BECO 88-126  
August 18, 1988

License DPR-35  
Docket 50-293

REVISED INFORMATION REGARDING PILGRIM STATION  
SAFETY ENHANCEMENT PROGRAM

Section 3.2 Revision 1 "Installation Of A Direct Torus Vent System (DTVS)"

FIGURE 3.2-1

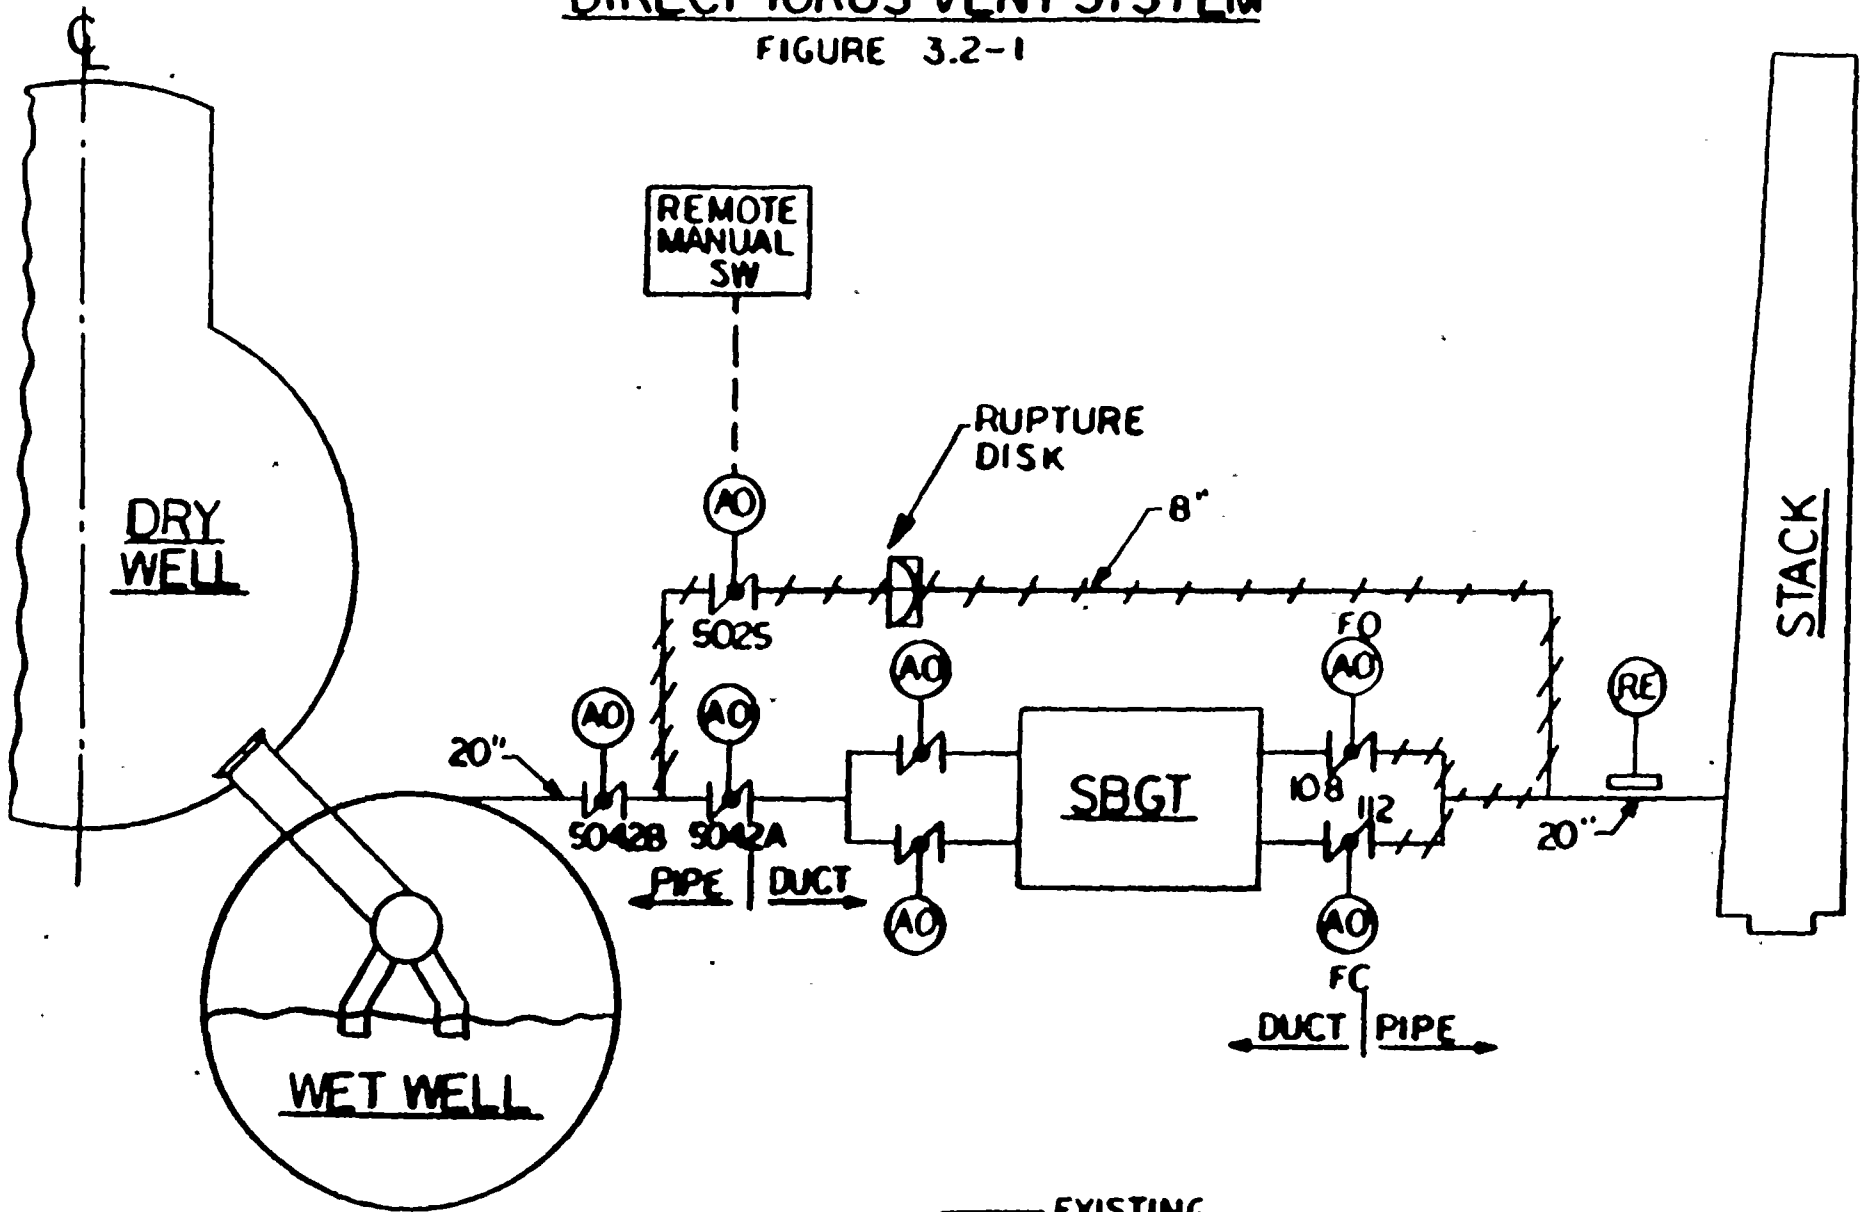
This design change (Figure 3.2-1) provides a direct vent path from the torus to the main stack bypassing the Standby Gas Treatment System (SBGTS). The bypass is an 8" line whose upstream end is connected to the pipe between primary containment isolation valves AO-5042 A & B. The downstream end of the bypass is connected to the 20" main stack line downstream of SBGTS valves AON-108 and AON-112. An 8" butterfly valve (AO-5025), which can be remotely operated from the main control room, is added downstream of 8" valve AO-5042B. This valve acts as the primary containment outboard isolation valve for the direct torus vent line and will conform to NRC requirements for sealed closed isolation valves as defined in NUREG 0800 SRP 6.2.4. The new pipe is ASME III Class 2 up to and inclusive of valve AO-5025. Test connections are provided upstream and downstream of AO-5025.

The design change replaces the existing AC solenoid valve for AO-5042B with a DC solenoid valve (powered from essential 125 volt DC) to ensure operability without dependence on AC power. The new isolation valve, AO-5025, is also provided with a DC solenoid powered from the redundant 125 volt DC source. Both of these valves are normally closed and fail closed on loss of electrical and pneumatic power. One inch nitrogen lines are added to provide nitrogen to valves AO-5042B and AO-5025. New valve AO-5025 will be controlled by a remote manual key-locked control switch. During normal operation, power to the AO-5025 DC solenoid will also be disabled by removal of fuses in the wiring to the solenoid valve. This satisfies NUREG 0800 SRP 6.2.4, Containment Isolation System acceptance criteria for a sealed closed barrier. An additional fuse will be installed and remain in place to power valve status indication for AO-5025 in the main control room.

A 20" pipe will replace the existing 20" diameter duct between SBGTS valves AON-108, AON-112 and the existing 20" pipe to the main stack. The existing 20" diameter duct downstream of AO-5042A is shortened to allow fitup of the new vent line branch connection.

A rupture disk will be included in the 8" piping downstream of valve AO-5025. The rupture disk will provide a second leakage barrier. The rupture disk is designed to open below containment design pressure, but will be intact up to pressures equal to or greater than those which cause an automatic containment isolation during any accident conditions.
